MIL-R-83536/22
AMENDMENT 3
30 September 1996
SUPERSEDING
AMENDMENT 2
15 December 1995

MILITARY SPECIFICATION

RELAYS, ELECTROMAGNETIC, ESTABLISHED RELIABILITY, 3PDT,
LOW LEVEL TO 10 AMPERES, PERMANENT MAGNET DRIVE, HERMETICALLY
SEALED, ALL WELDED, TRANSIENT SUPPRESSED DC COIL

This amendment forms a part of MIL-R-83536/22, dated 27 March 1992, and is approved for use by all Departments and Agencies of the Department of Defense.

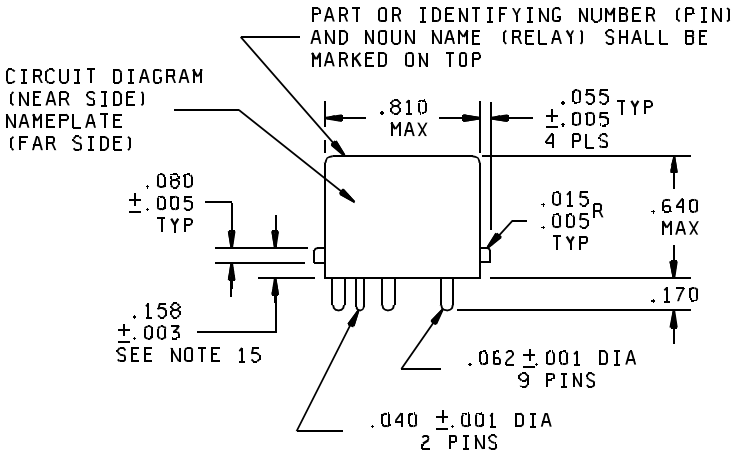
FIGURE 1, track mount A, side view, delete and substitute the following:

CIRCUIT DIAGRAM
(ALTERNATE INTERNAL
DIODE CONFIGURATION)

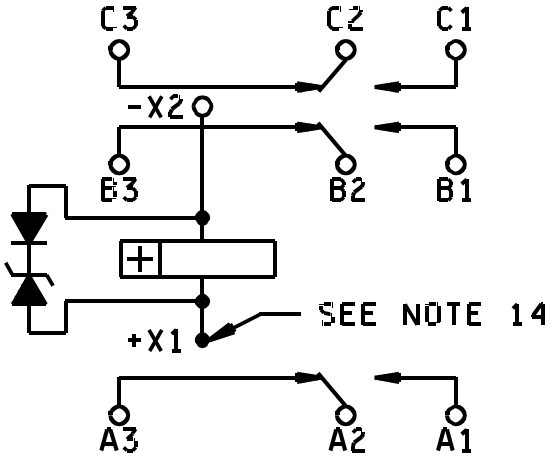
FIGURE 1, above figure title: Add "CIRCUIT DIAGRAM".

FIGURE 1, add the following circuit diagram:
